**CONTRACT DOCUMENTS & TECHNICAL SPECIFICATIONS & PLANS
ADDENDUM No. 1**

**CAPE HENLOPEN STATE PARK
PARK ROAD - COLLEGE OF EARTH, OCEAN, & ENVIRONMENT
CONTRACT NO. 2013-CH-400
June 14, 2013**

S-4A

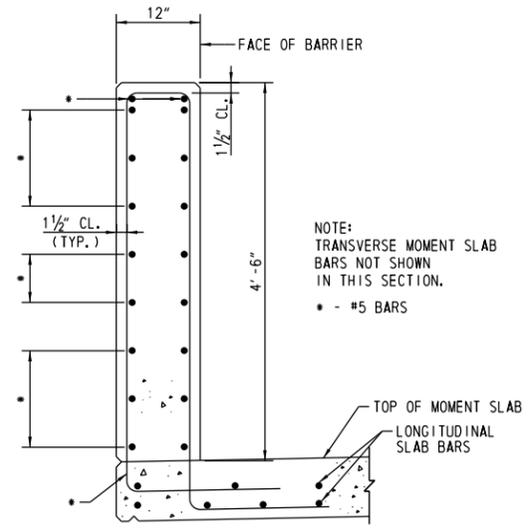
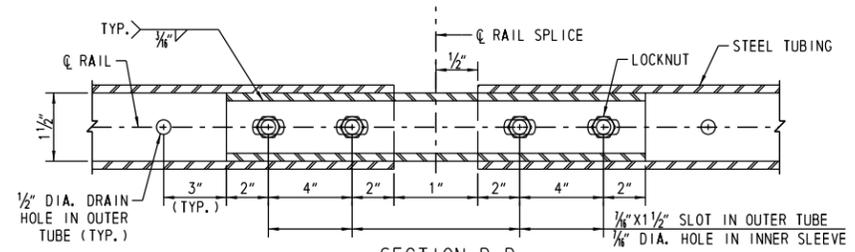
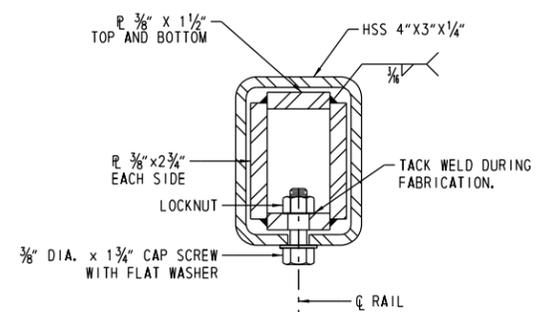
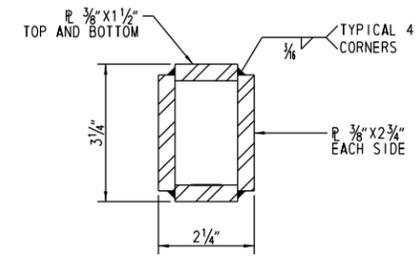
Sheet S-4A - Barrier/Railing Details

DATE: 6/13/13 DESCRIPTION: NEW SHEET
